Product Change Notification: E-19-017631

General Product Description:
AMP SUPERSEAL 1,5 SRS. PLUG ASS'Y

Description of Changes
1745096,1745083 and 1745085 drawings are replaced by 282080,282087 and 282090 with all details.
Other attachments:
Markup-1
ECR form
Markup-2

SIZE: A300779 CAGE CODE: C-282080 DRAWING NO: 1 OF 2 RESTRICTED TO: D3

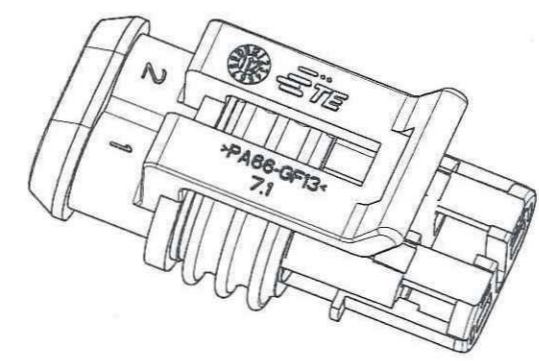
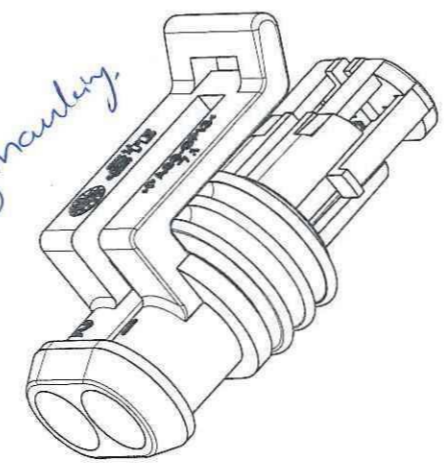
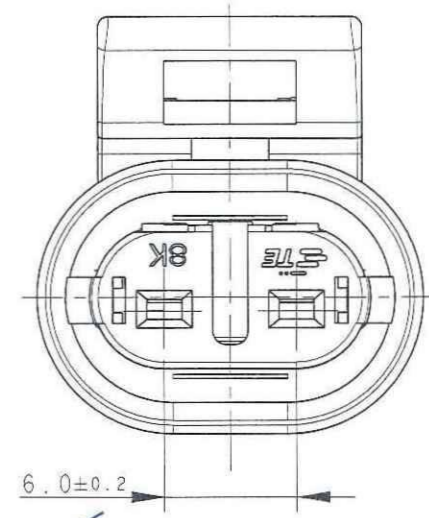
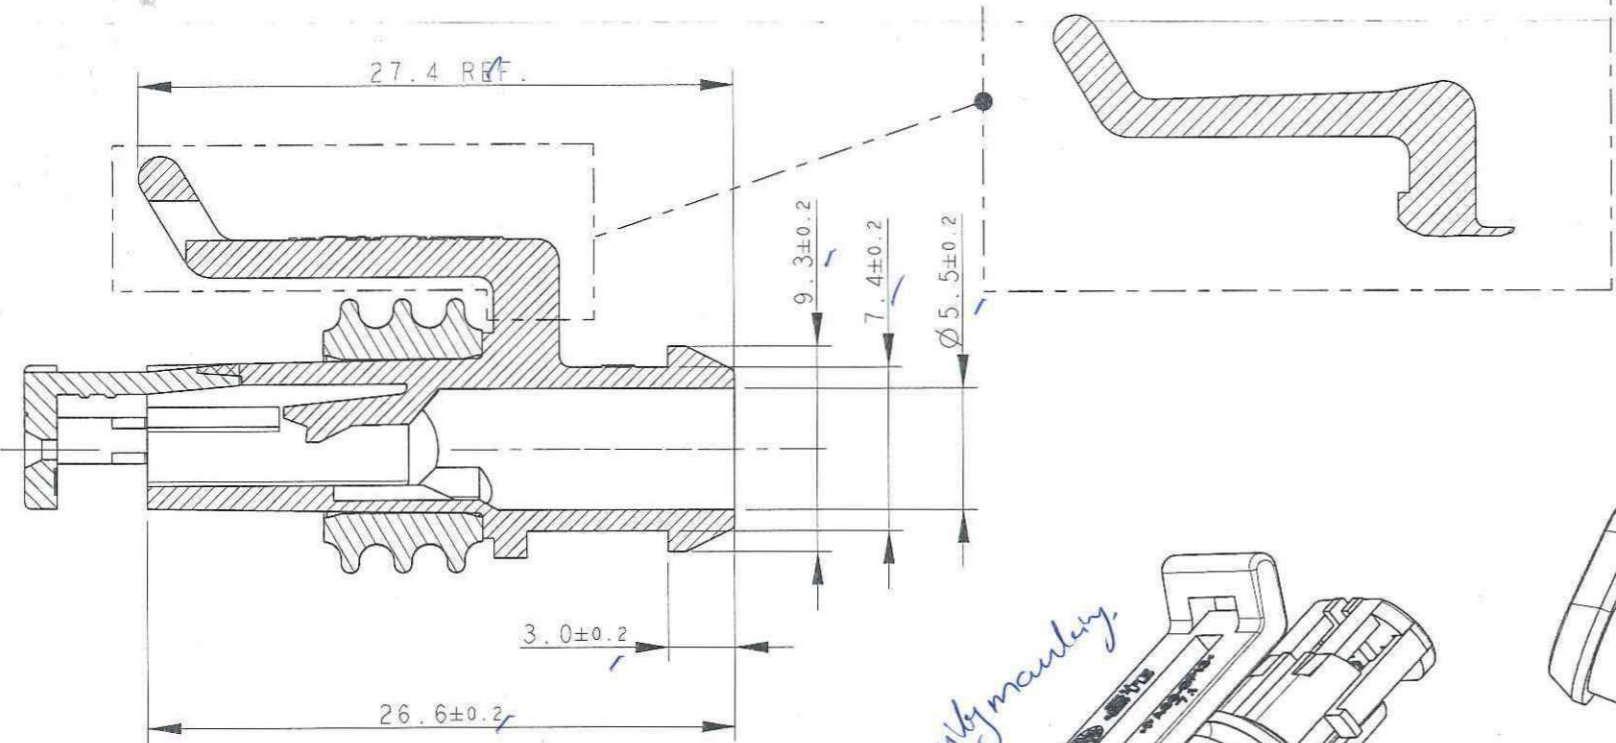
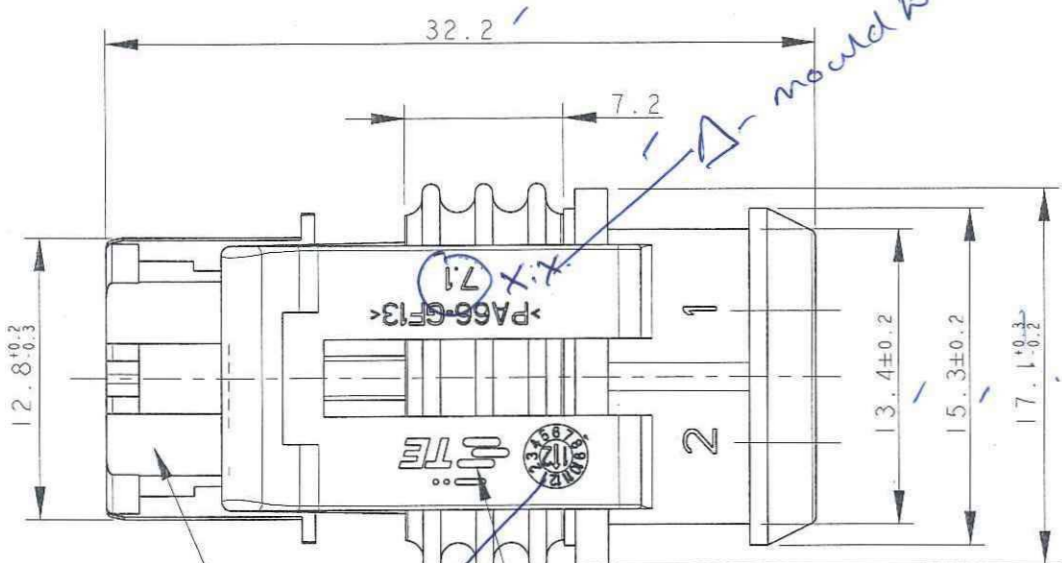
Handwritten note: H08TSL is PA66GF13 UL94-V2
 Sealing: LSR
 ALL TO IEC 60335-1

Handwritten note: mould not cavity moulding.

Handwritten note: High white mould Hsq+sf → PA66-GF13 1745096-1

Handwritten note: 41-Datecode (optional in old mould)

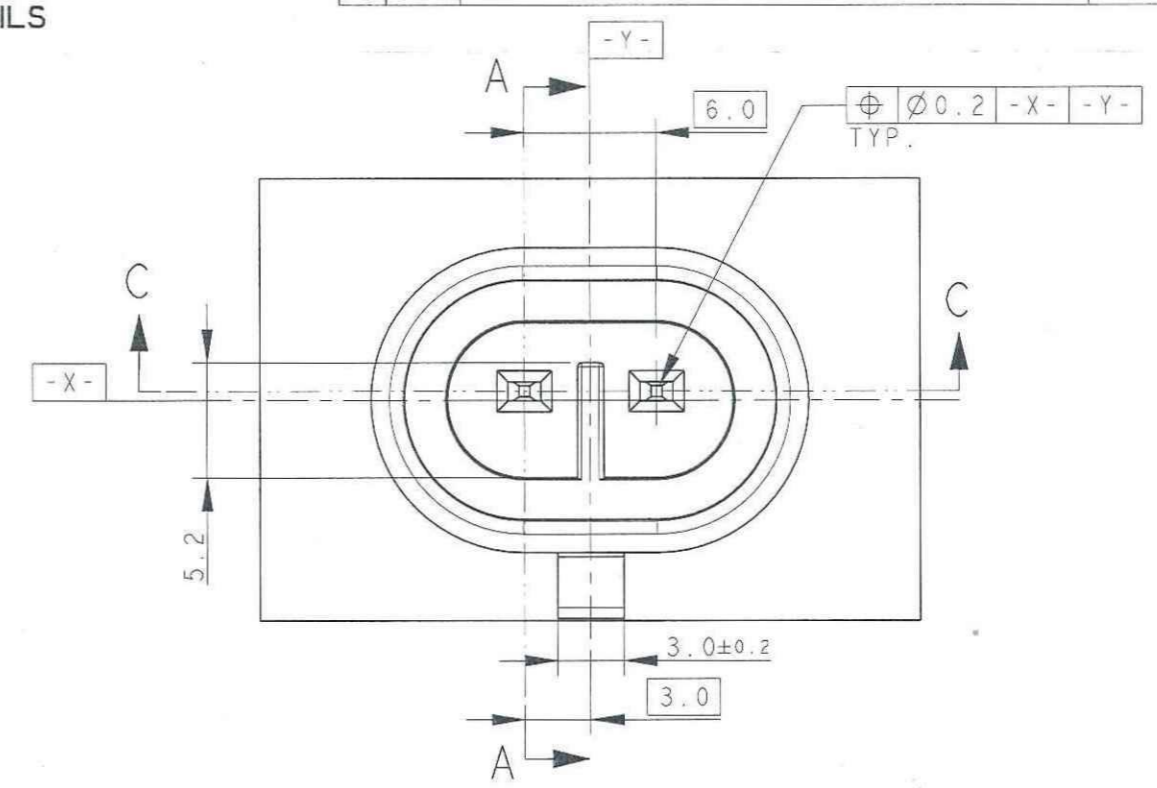
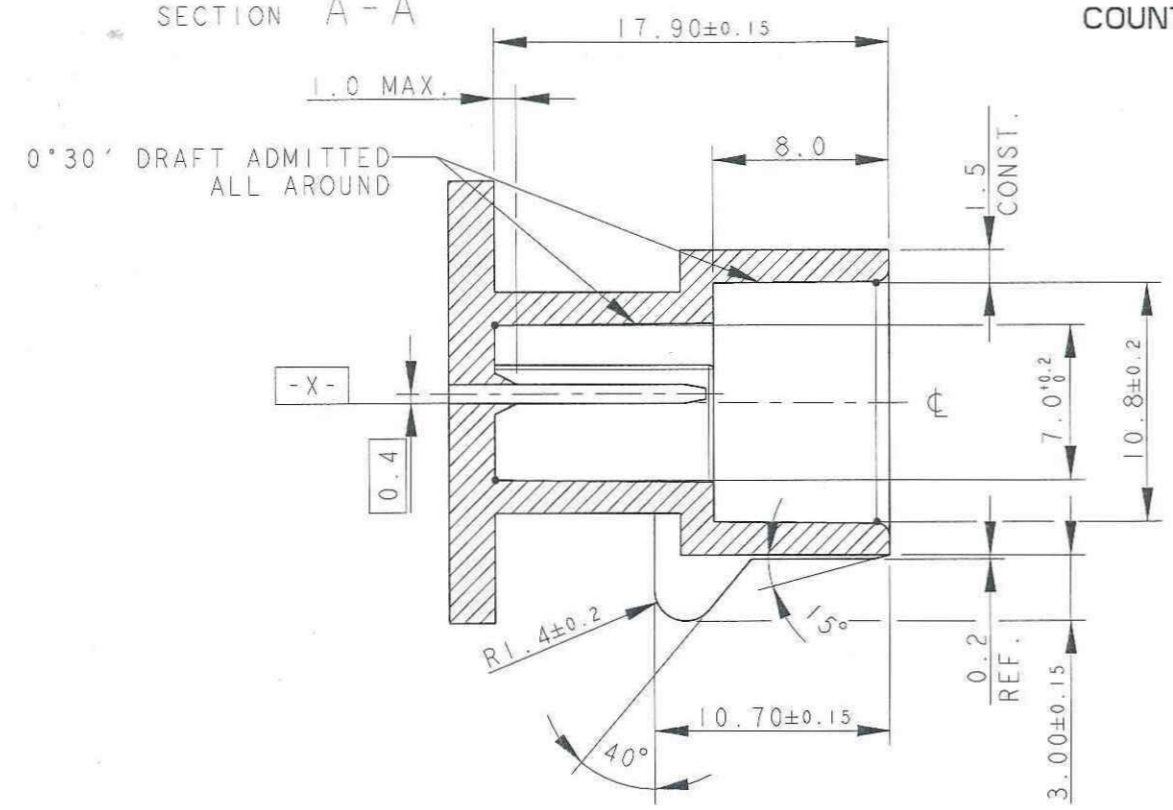
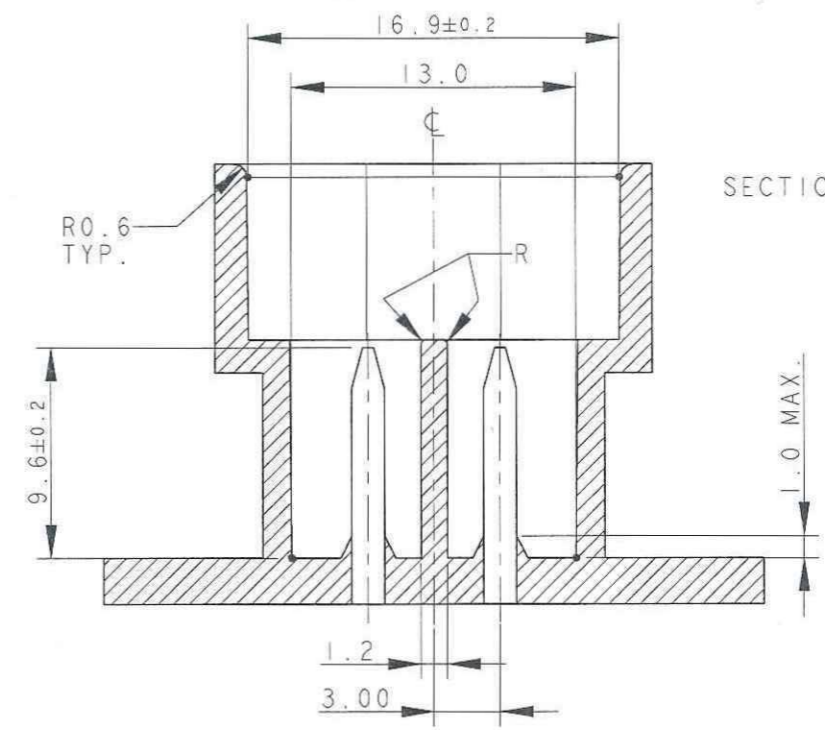
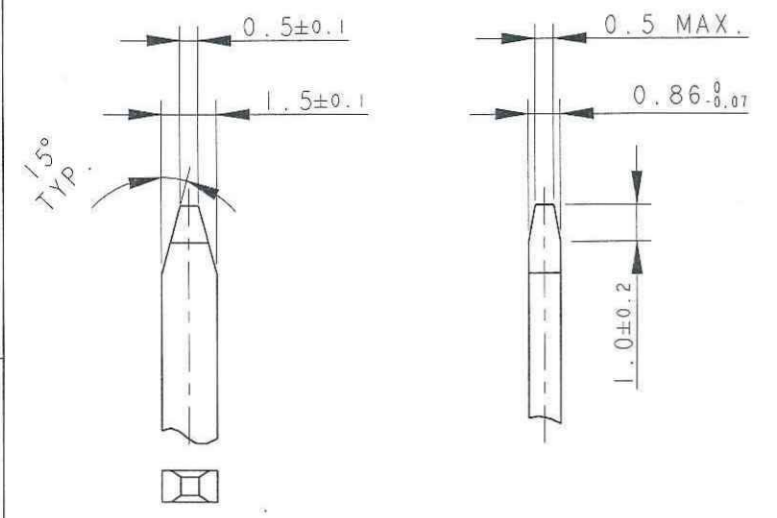
*For PN 1745096-1 →
 counterpart mch1
 PA66-GF Accp
 IEC60335-1*
